VALUE ENGINEERING PROPOSAL

PROPOSAL NO: S-7 PAGE NO: 1 OF 5

DESCRIPTION: Use a Precast Post Tensioned Concrete Star Pile

DRAWING NO. 1

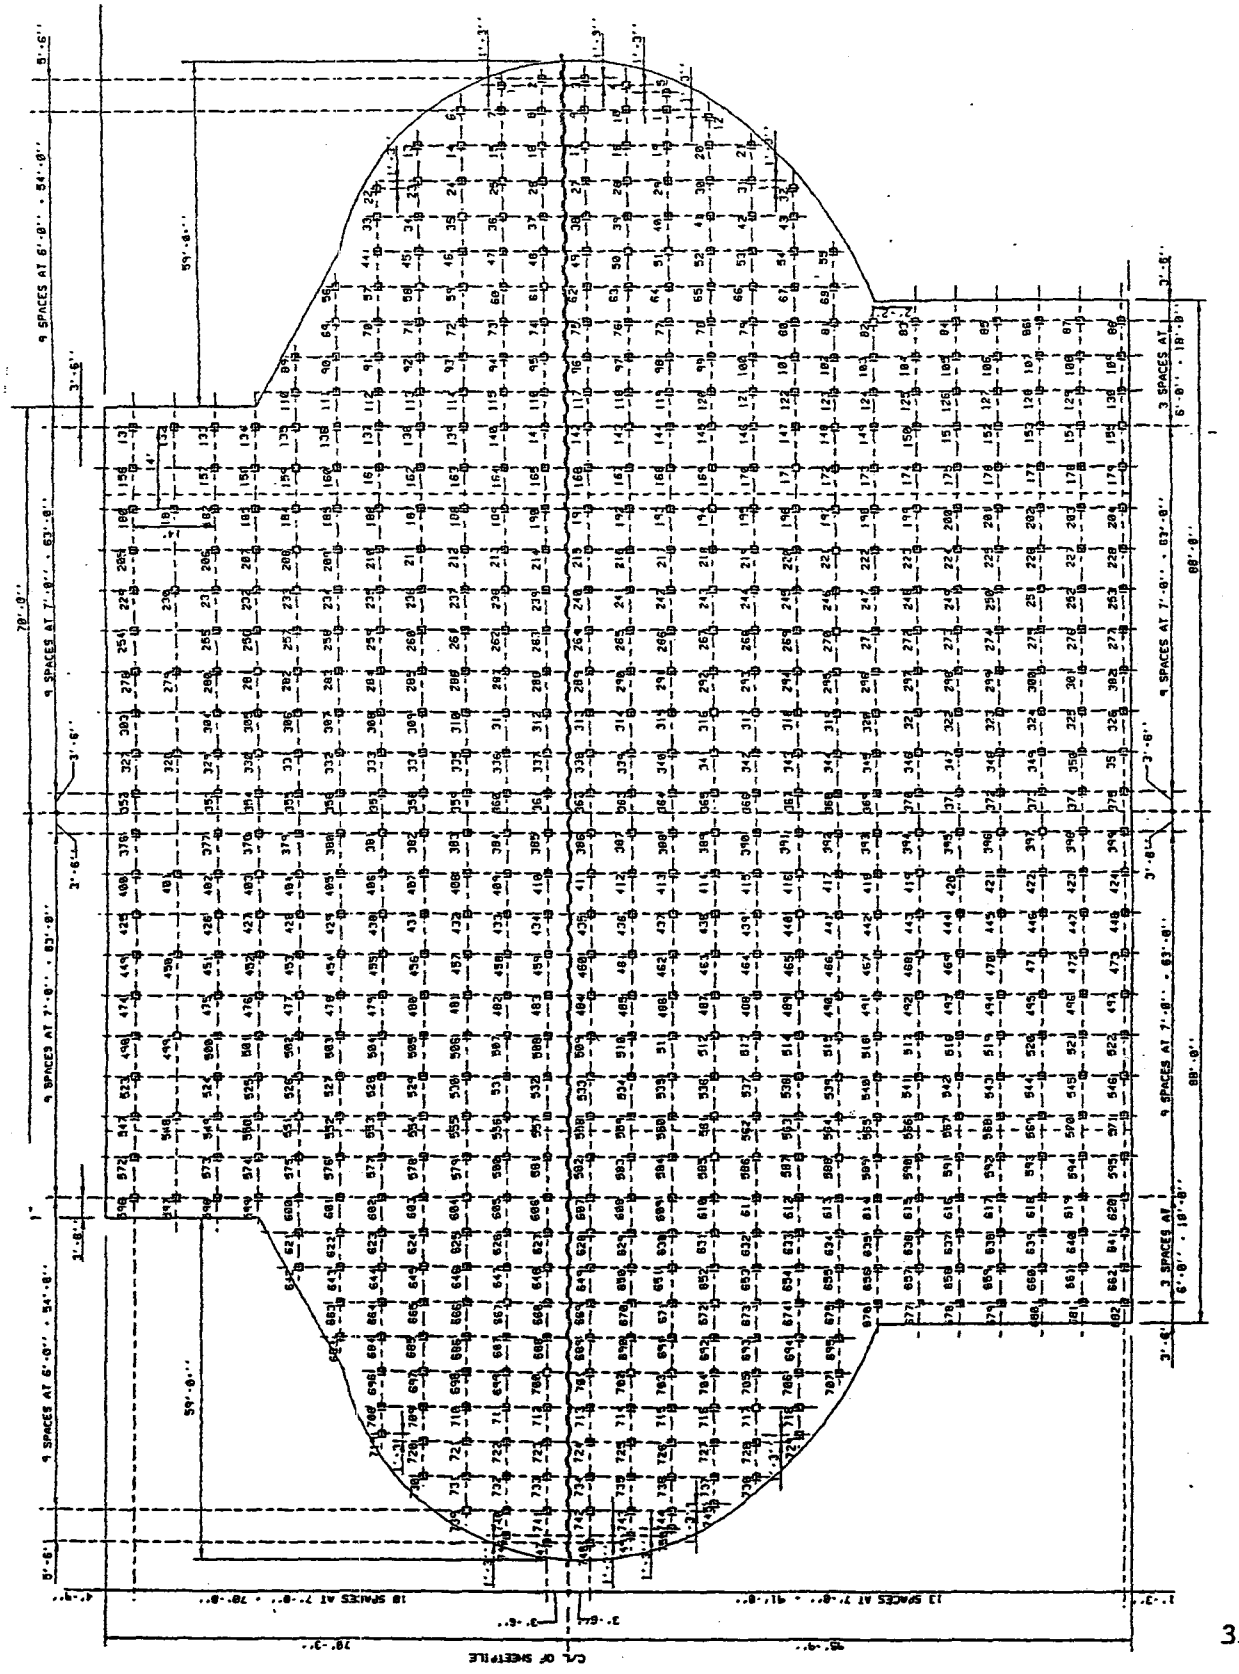
ORIGINAL DESIGN:

Specified 14" precast concrete piles. (750 per gate). (See Drawing No 1).

DRAWING NO. 2

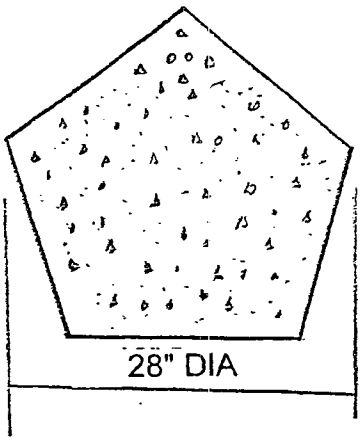
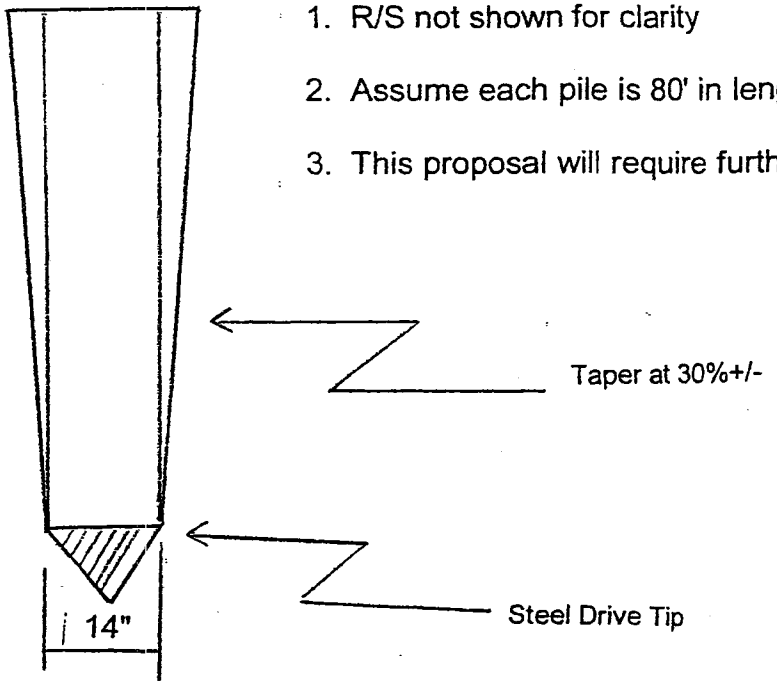
PROPOSED DESIGN:

Design a concrete pile, pentagonal shape. (See Drawing No 2). The 5 sided pile is 28" in diameter and is tapered. This pile has been used successfully in Europe in a marine environment. The rational behind the design is to increase the friction co-efficient and reduce the overall number of piles. (See Drawing No 3)

DRAWING NO. 3

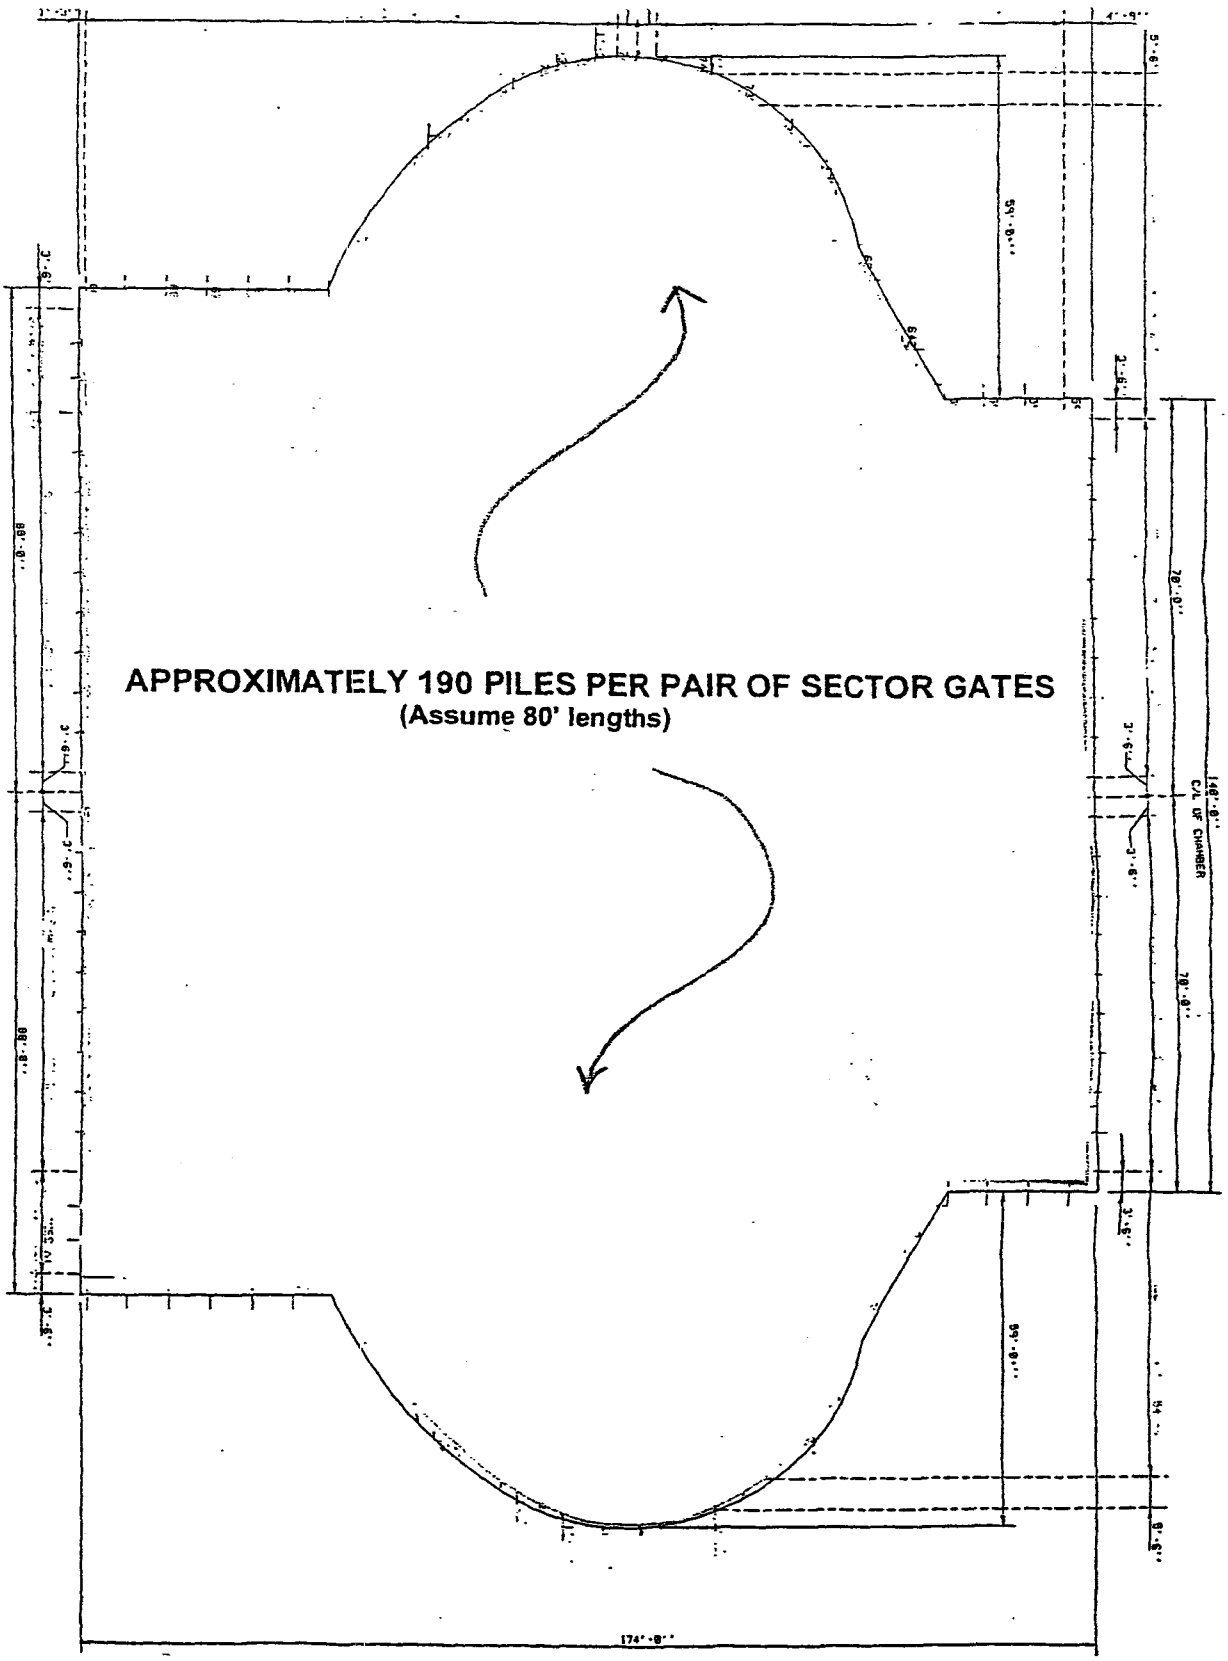
APPROXIMATELY 190 PILES PER PAIR OF SECTOR GATES
(Assume 80' lengths)
C/L OF CHAMBER
